Access Compliance Report

Public Rights-of-Way

(Curb Ramps)

Intersection ID: 17677	Main Street: BROADMOOR_DR	Cross Street: SCALEYBARK_RD	Location:	N
ADA ID: 4459E02597BD	Ramp Type: Directional1	Initial Pass/Fail: Pass	Overall Compliance: No	Severity Score: 0

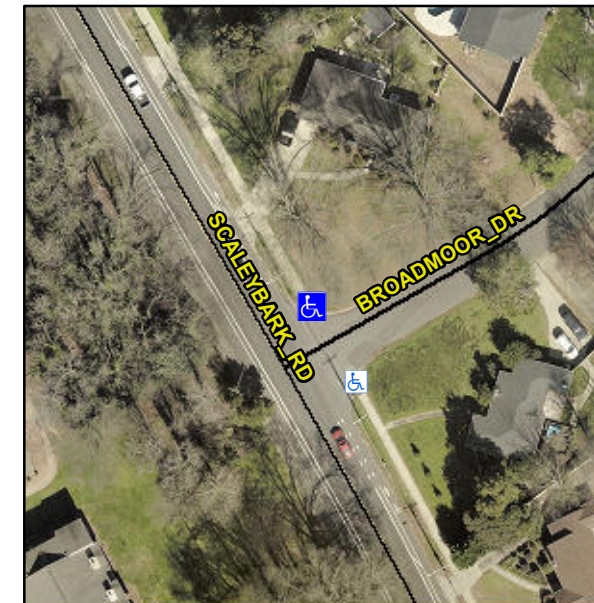
**Not Found, R304.2.2-Perp, R304.3.2-
Para, R304.5.2, R305.2, R304.5.3**

**Remove & Replace Entire Ramp.
Remove & Replace Gutter.**
